Preparation of the AB 1632 Nuclear  
Power Plant Assessment Report,  
2008 Integrated Energy Policy Report  
Update, and the 2009 Integrated Energy Policy  
Report

Docket No. 07-AB-1632  
Docket No. 08-IEP-1F

**COMMENTS OF THE CALIFORNIA  
INDEPENDENT SYSTEM OPERATOR ON  
CONSULTANT'S DRAFT REPORT ENTITLED *AB 1632  
ASSESSMENT OF CALIFORNIA'S OPERATING NUCLEAR  
PLANTS***

# CAISO Comments on: AB 1632 Assessment of California's Operating Nuclear Plants - Draft Report

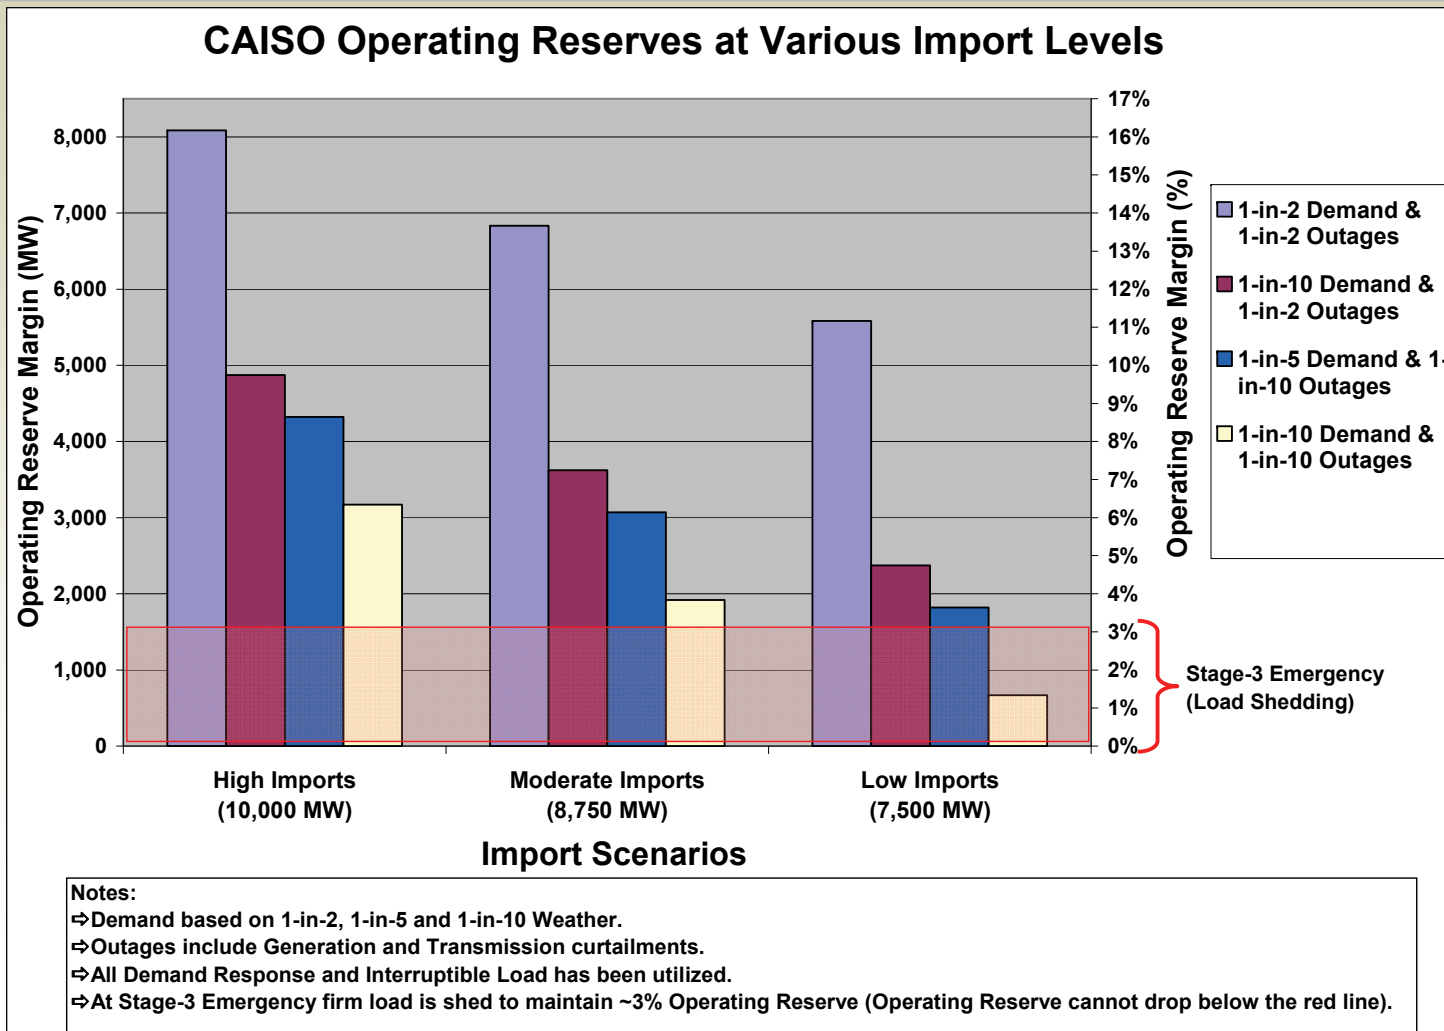
- “Table 6 shows that under normal conditions and given current loads and resources, there is a 23.9 percent planning reserve margin, which is well above the CPUC’s required resource adequacy margin of 15 percent to 17 percent. (p. 202)

- Table 6 is based on a “planning perspective” based on various planning assumptions, not normal conditions.
- The 19.9% - 23.9% planning reserve margins represented were projections of what is now a historical timeframe and it is not appropriate to use these planning reserve margins to make conclusions about potential future events.
